## NEW MEXICO OIL CONSERVATION DIVISION

Ross Ranch 10 Fed #1

RE: Form C-108, Application for Authorization to Inject  
Ross Ranch 10 Fed 1; API# 30-015-29605  
Eddy County, NM  
Section 10, T26S, R31E; 1980' FNL & 660' FEL

**APPLICATION FOR AUTHORIZATION TO INJECT**

## CURRENT WELLBORE

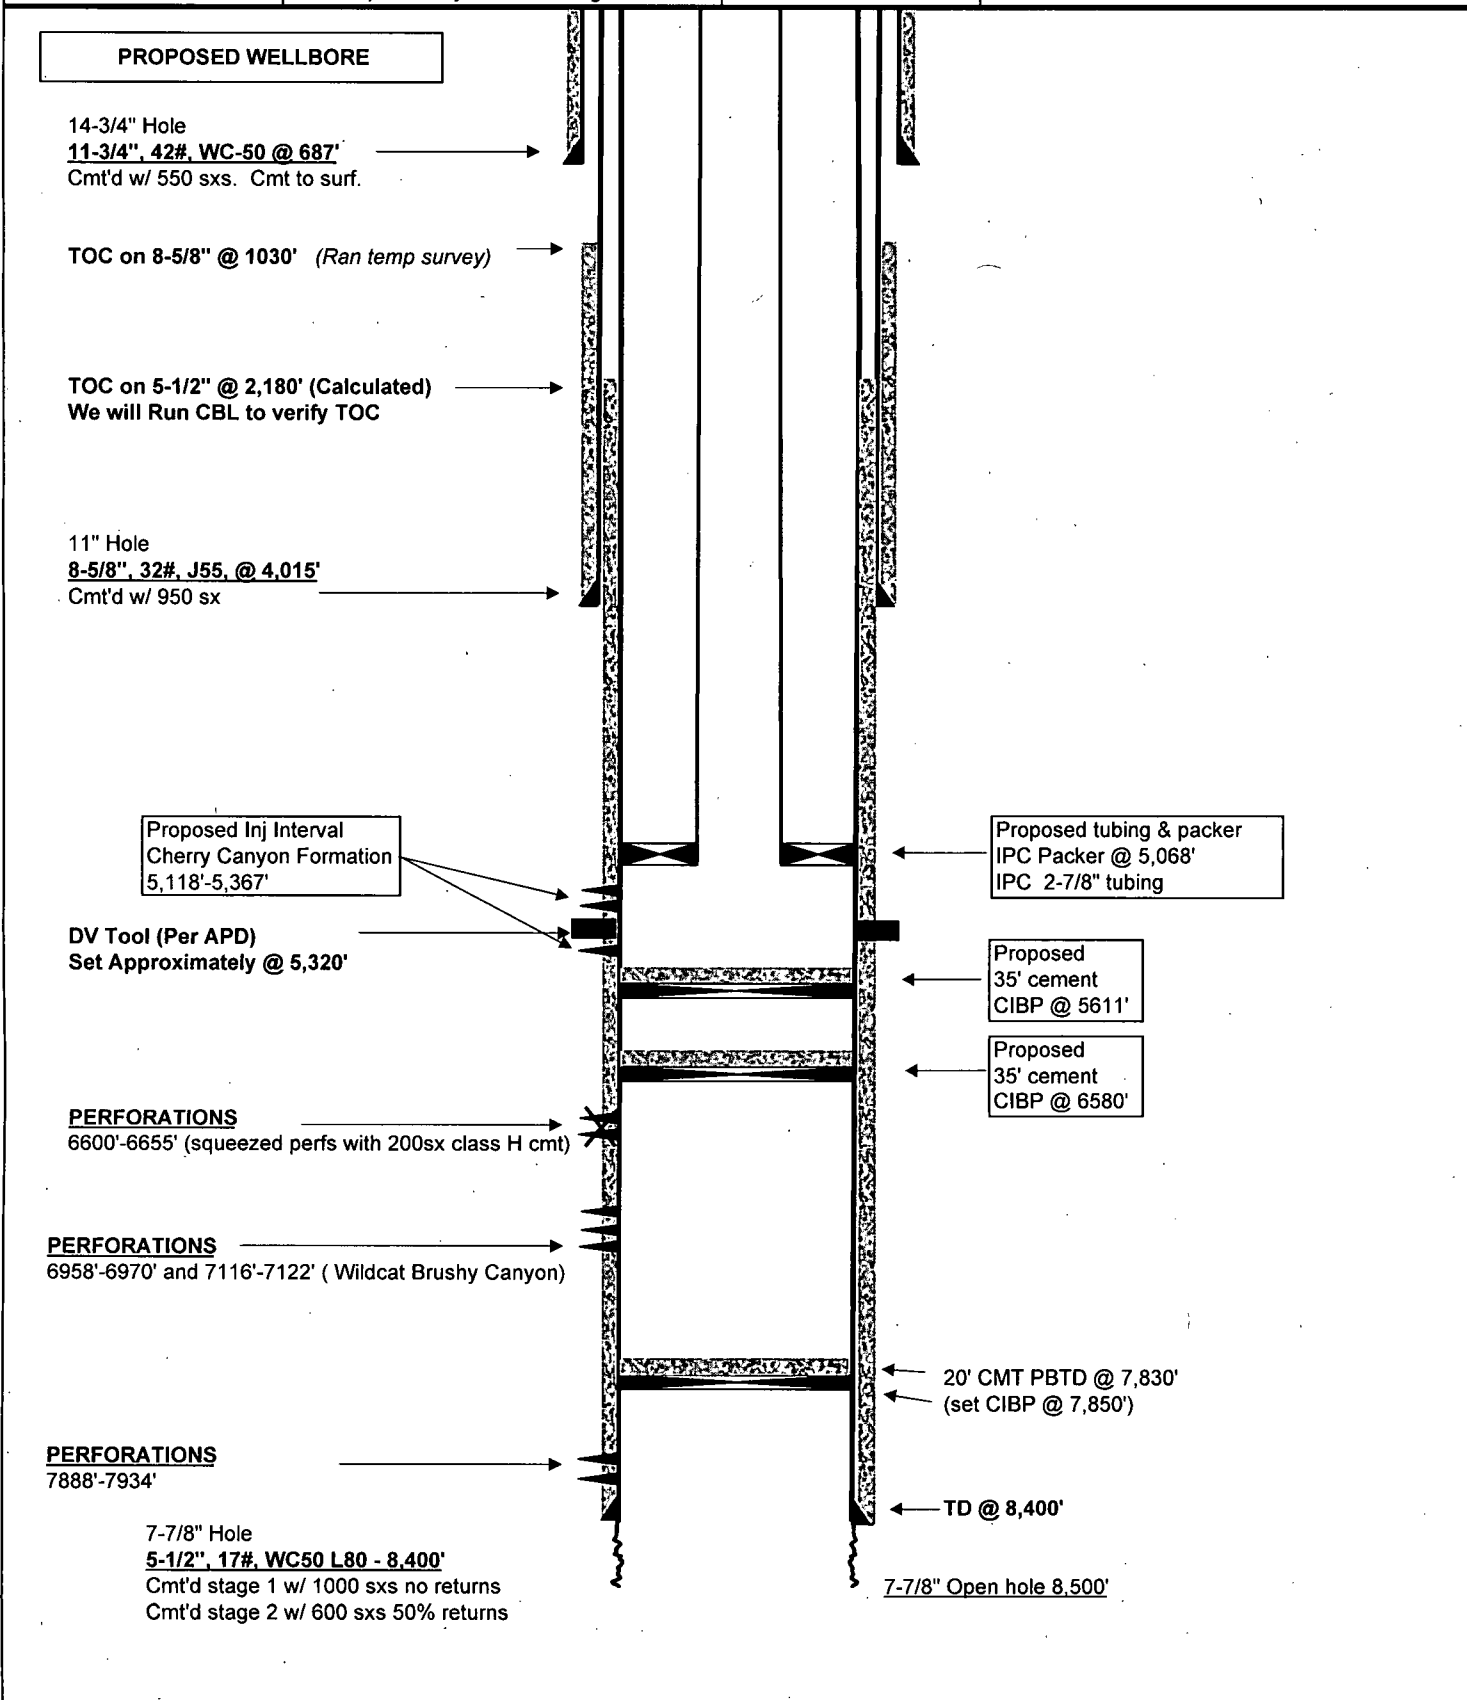
We will Run CBL to verify TOC

Issues: Run CBL  
Sat CIBR 5615' OK
